**[Docket No. FAA-2014-0337; Directorate Identifier 2013-SW-029-AD]**

**Airworthiness Directives; Various Restricted Category Helicopters**

**ACTION:** Notice of proposed rulemaking (NPRM).

Figure 1 to Paragraph (f)

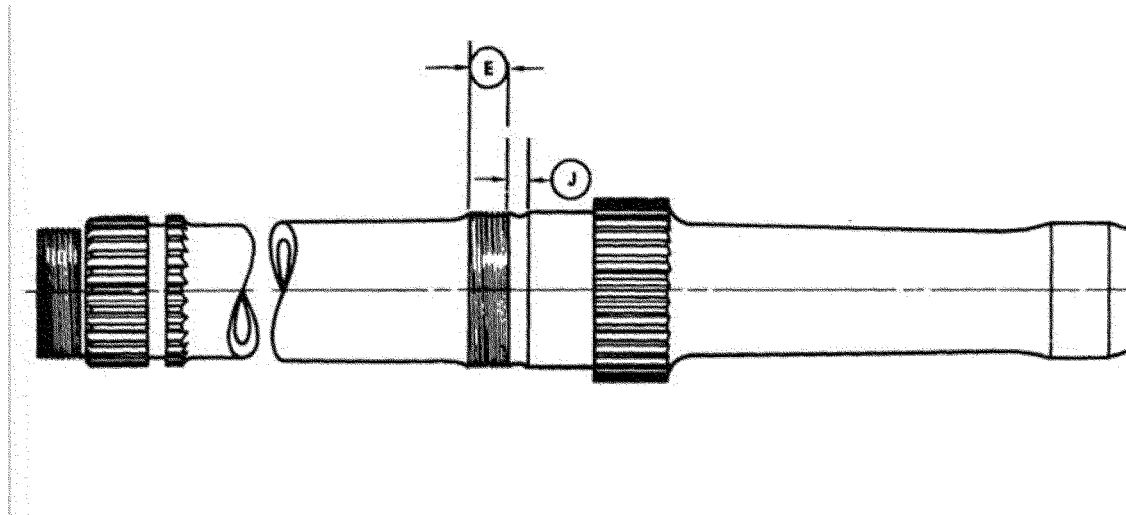
The National Transportation Safety Board (NTSB) commented in support of the required inspection of the threaded area of the mast for a crack, pitting, or corrosion, but requested that the area adjacent to the threaded area (identified in AD 2012–14–11 as “area J”) be added

to the visual inspection requirements of the proposed AD. The NTSB states that a prior accident investigation revealed the mast had fractured in this section. We agree with this comment. Although AD 2012–14–11 does contain a requirement for magnetic particle inspecting the entire mast for a crack, we have included the expanded area in the visual inspection requirements in the proposed AD.

- (i) Remove any surface rust with a wire brush or steel wool and, using a 10X or higher power magnifying glass, inspect the areas of the mast as shown in area E and area J of Figure 1 to Paragraph (f) of this AD for pitting, corrosion, or a crack.
- (ii) Overhaul the main rotor mast assembly and magnetic particle inspect the mast; mast bearing nut; plate, mast and seal; and bearing liner for a crack.
- (iii) Fluorescent penetrant inspect the locking plate for a crack.
